MONITORING YEAR 4 ANNUAL REPORT

ALEXANDER FARM MITIGATION SITE

Subject: Final Year 4 Monitoring Report Review
Alexander Farm Mitigation Site, Alexander County
Yadkin River CU 03040101
DMS Project ID No. 100022 / DEQ Contract #007186

Figure 1a. Current Condition Plan View
 Alexander Farm Mitigation Site
 DMS Project No. 100048
 Monitoring Year 4 - 2023
 Alexander County, NC

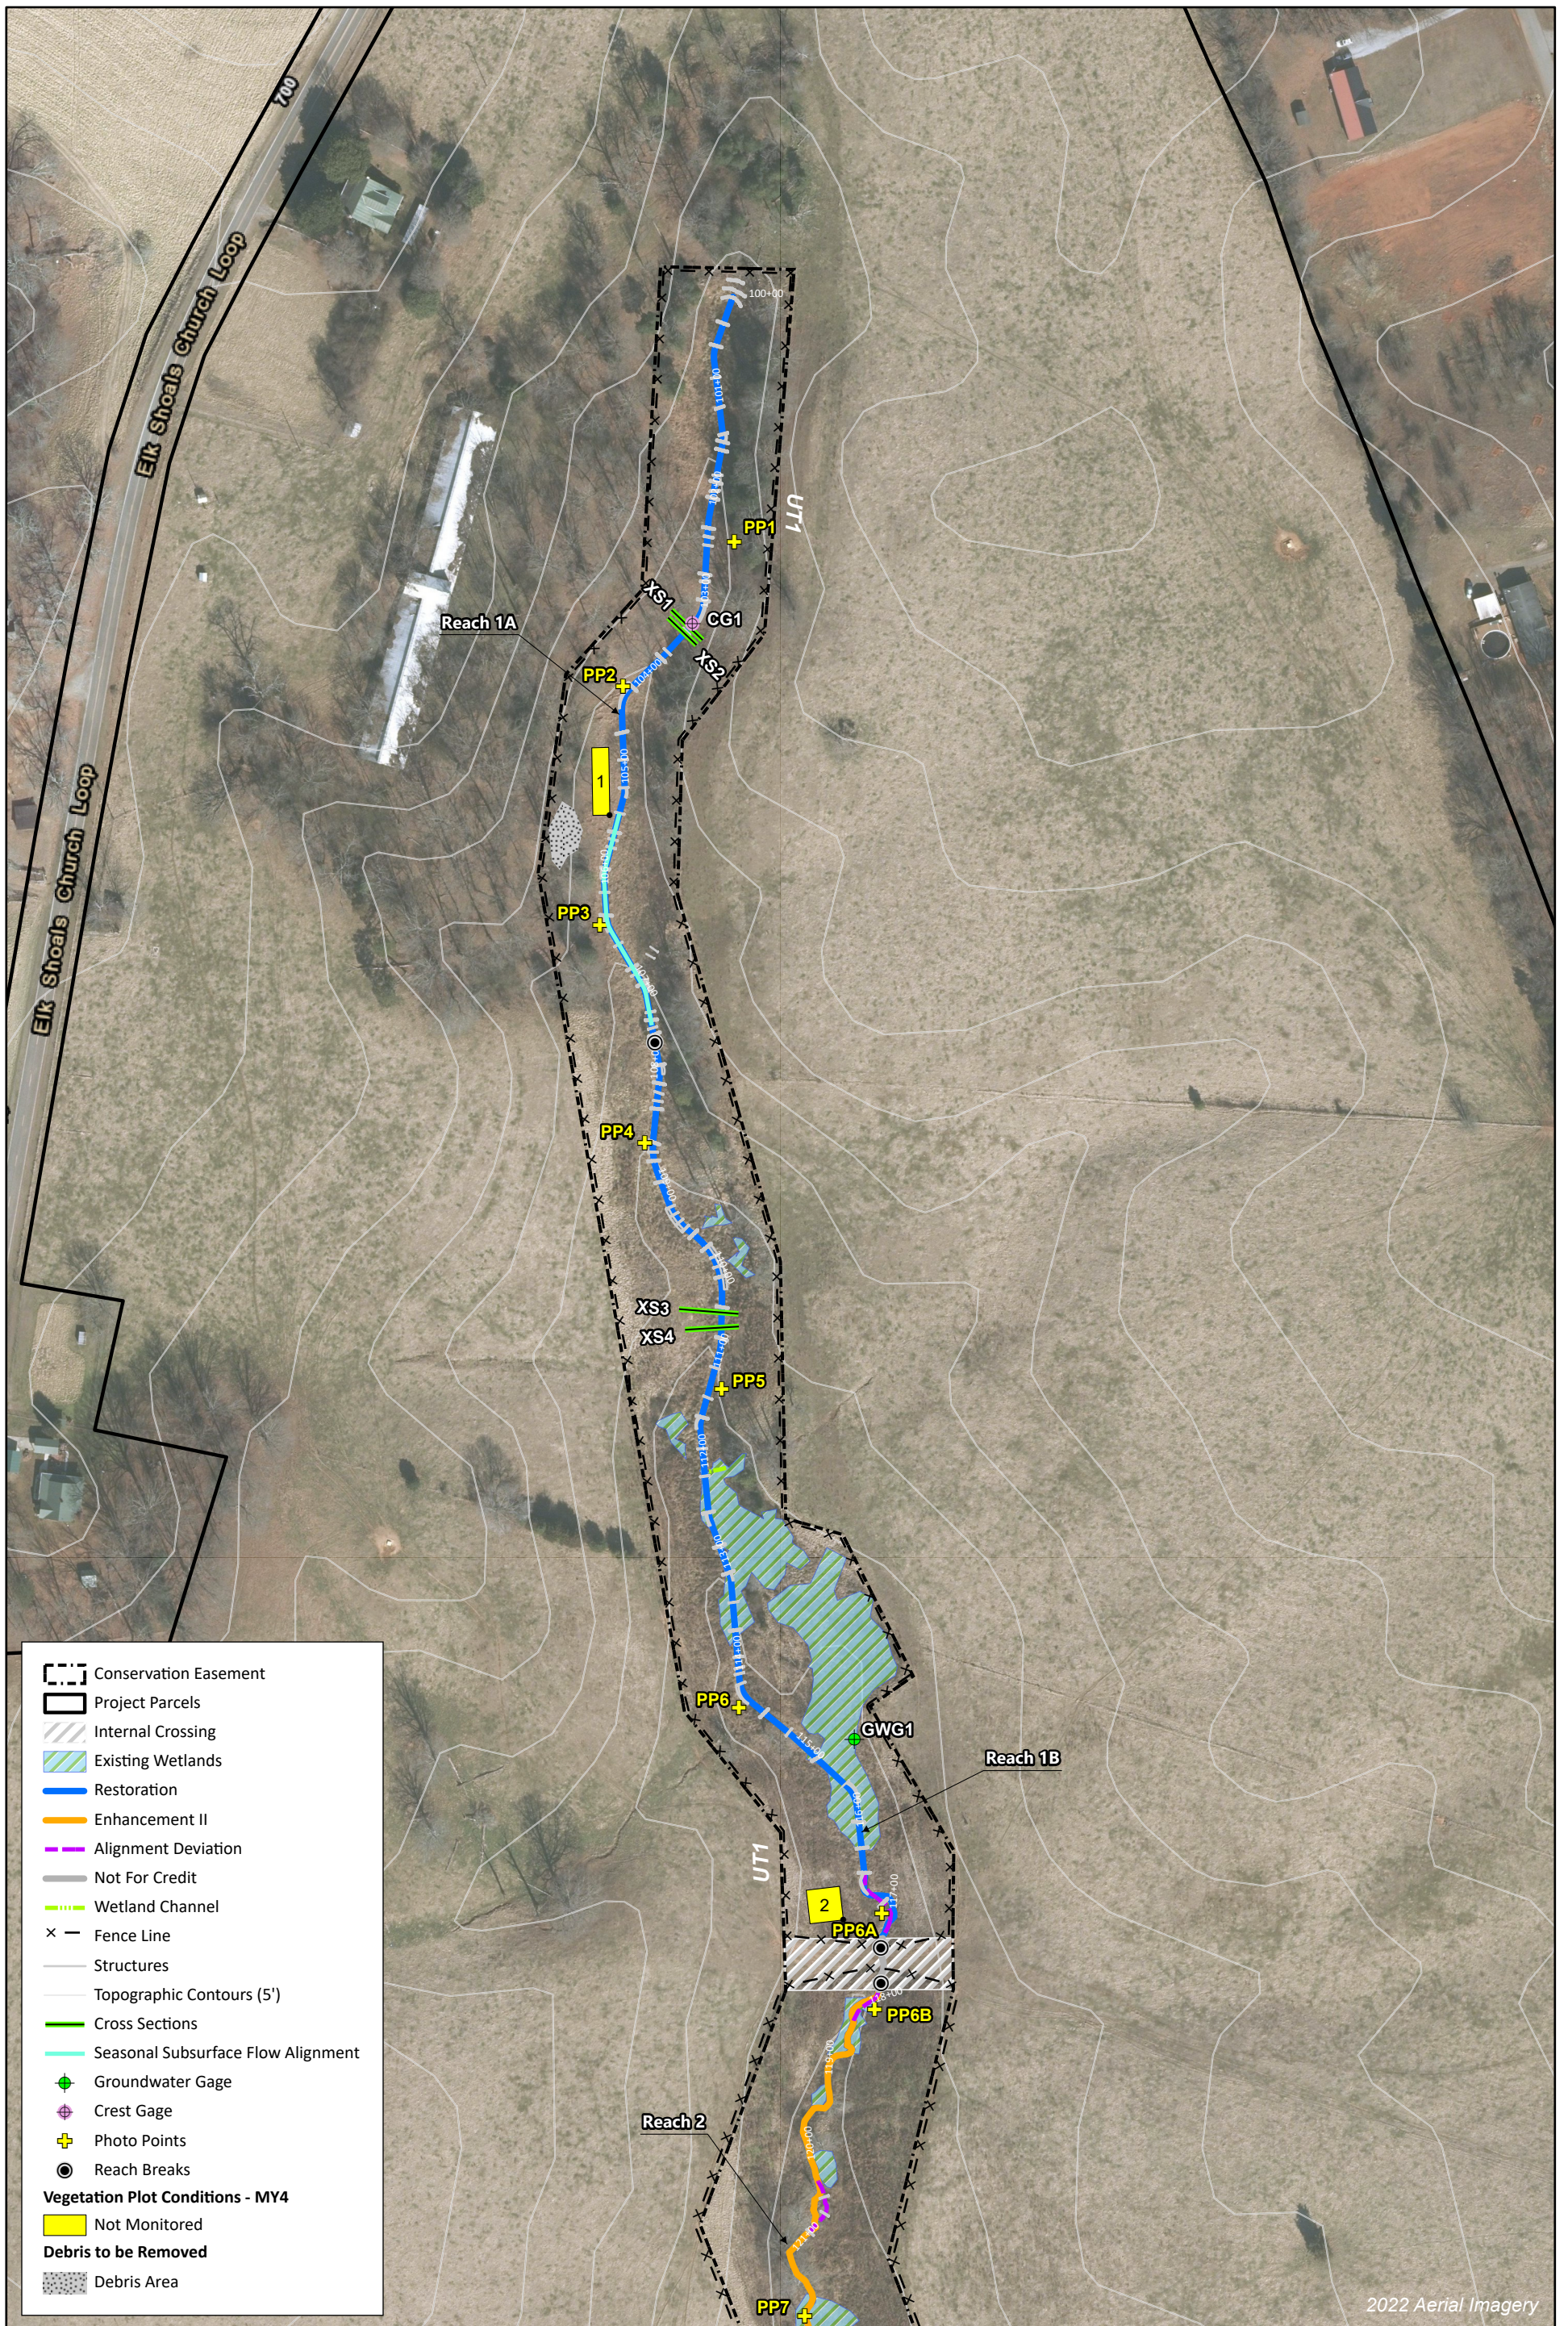
DMS' comment: Figure 1A should denote the location of the concrete debris / dismantled chicken house foundation that is slated for removal. Since this part of the easement is with a new (since project acquisition) landowner, as requested following that site visit, please provide DMS with the new landowner contact information (name, address, email, telephone). This is needed for the landowner contact database that will eventually be needed for DEQ-stewardship. If other landowners have changed, please also provide their information. Please work with the landowner and/or contractor to remove the debris with as little impact to the existing canopy/vegetation as possible.

DMS' comment: The subsurface stream flow repair area location (s) should be shown on Figure 1A; has the length of the affected area changed since 2022? Should this reach be reflected in the visual assessment table for reach 1A?

Wildlands' response: Figure 1A now denotes the location of the debris on UT1 Reach 1A. Wildlands checked Alexander County's GIS website for the current landowner information. It shows that the original landowners still own the property that contains the easement, so there is no new landowner information. The parcel that was sold and has a new landowner does not contain any of the conservation easement. Wildlands is currently working with the landowner to see if they can and will remove the debris inside of the easement. If the landowner cannot remove the debris from the easement, then Wildlands construction will do it.

Wildlands' response: The subsurface stream flow area has now been added to Figure 1A. The polyline on the CCPV map shows the location of the subsurface flow that only occurs during very dry Site conditions, and its length is variable depending on the weather. Since the subsurface flow is not caused by a structural issue or stream bed aggradation or degradation, including the area on the visual assessment

table (Table 4a) is unnecessary. Wildlands will continue to monitor this section for any other problems and will deal with them as they occur.
